# Dimensional Drawing
# VAC Positioner V200 P and E

| VAC | File: 91900r5_160421_V200 PP_EP STD_Dim Drawing | |
| | Drawn by / date: Lennart Nord / 05 08 03 | Part no: **91900 r5** |

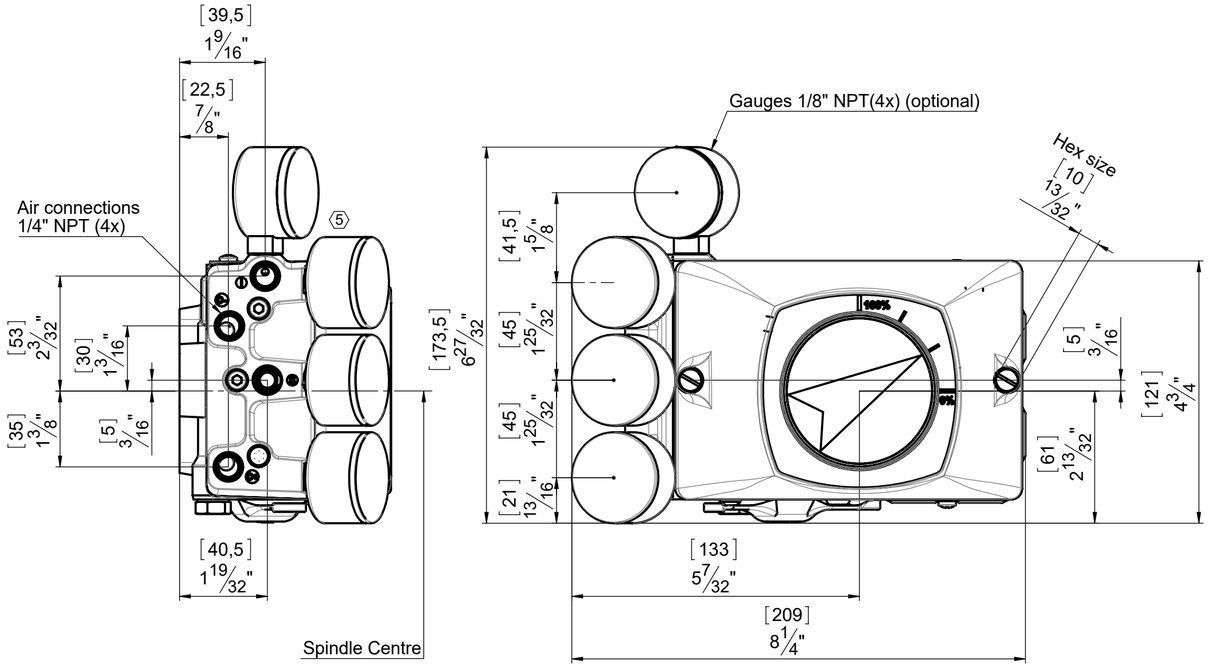
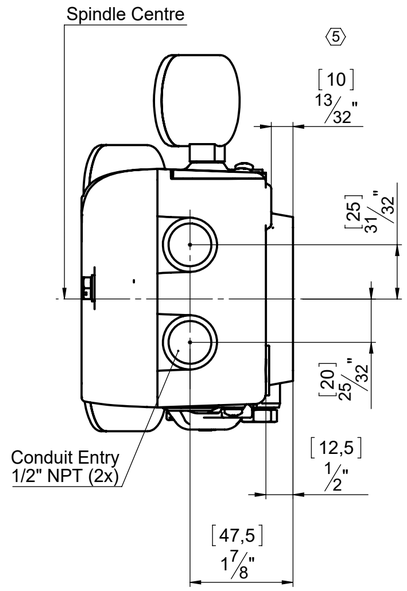
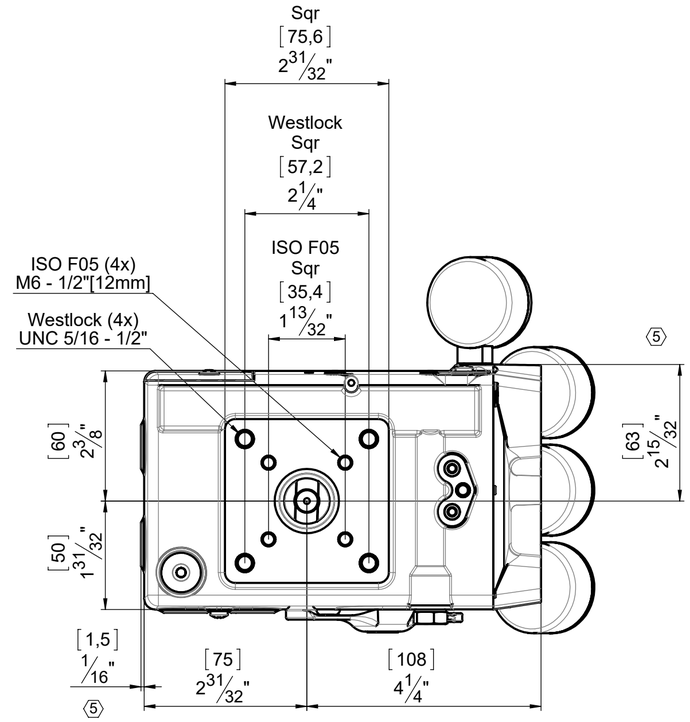
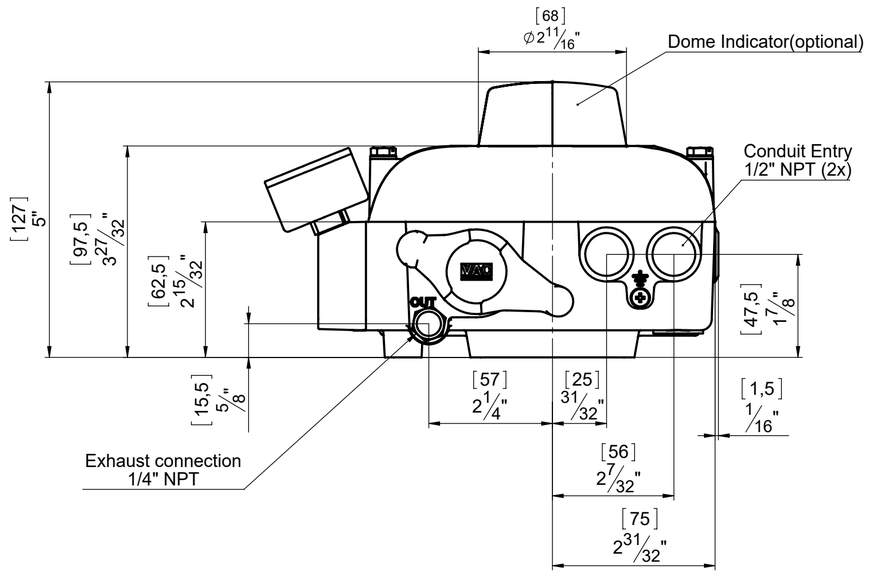
| REV. | DESCRIPTION | DATE | BY |
|---|---|---|---|
| 5 | Drawing updated. The I - connection 1/4" NPT-hole moved upward 0,5mm = .02" (dim 53mm was 52,5mm) and few missing dimensions added. | 2016-04-21 | LN |
